Agilent 5071A Primary Frequency Standard Telecommunications Options

Telecommunications
Options Supplemental
Manual

CHANGE DATE: December 12, 2001

# MANUAL CHANGES AGILENT 5071A TELECOMMUNICATIONS OPTIONS SUPPLEMENTAL MANUAL

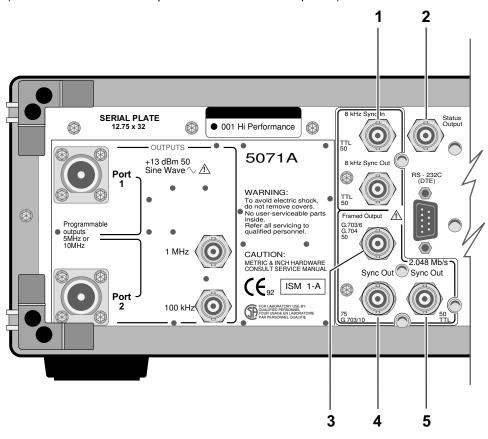
Option 048:

Item 9 is absent.

Item 10 Connector Type is a 5-screw terminal strip.

Item 10 Signal Characteristics are 40-58 Vdc on the rear-panel terminal strip dc-power inputs 1 and/or 2 with GND as chassis ground.

# **5071A Rear Panel Connections**

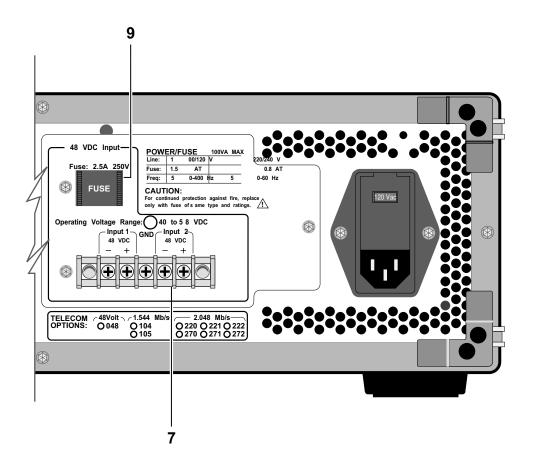
<u>Table 1-1 Connector Descriptions items in the Operating and Programming manual are changed:</u>

**Any TCO Option:** Items 5 and 6 are absent from the rear-panel.

The illustration on these pages depicts an 5071A equipped with Telecomm Options 048 and 272. When the telecomm output option includes either 100 or 120  $\Omega$  balanced output lines, the Framed Output connector will be a two-center-conductor BNC in place of the one shown above. In addition, the Mb/s and impedance designations will correspond to the particular telecomm output option shipped with the 5071A.

Figure 2-1. DC Input 1 and 2 Power Steering Schematic (48V Subpanel Assembly, part number 05071-60277)

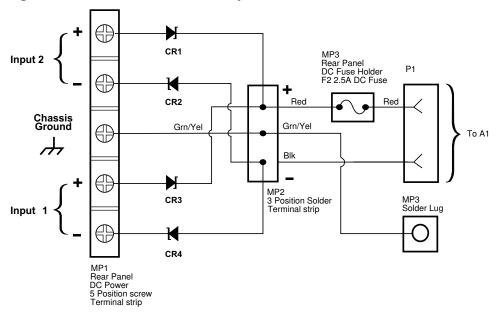
Use the DC Input 1 and 2 Power Steering Circuit Schematic (Figure 2-1.) located on page 17 of this chapter to troubleshoot the dc power input steering function.

The schematic diagram in figure 2-1 below illustrates the wiring of the 48V Subpanel Assembly. This assembly steers dc input power, and provides fuse protection for the external 48V external dc input power. The output of this circuit at P1 is routed to the input of the External DC Input Filter Block (J1) illustrated at the top-left comer of figure 3-3. in the 5071A Assembly-Level Service manual.

**Option 048:** The 48V Subpanel Assembly illustrated by the schematic diagram shown in Figure 2-1 is part number 05071-60277.
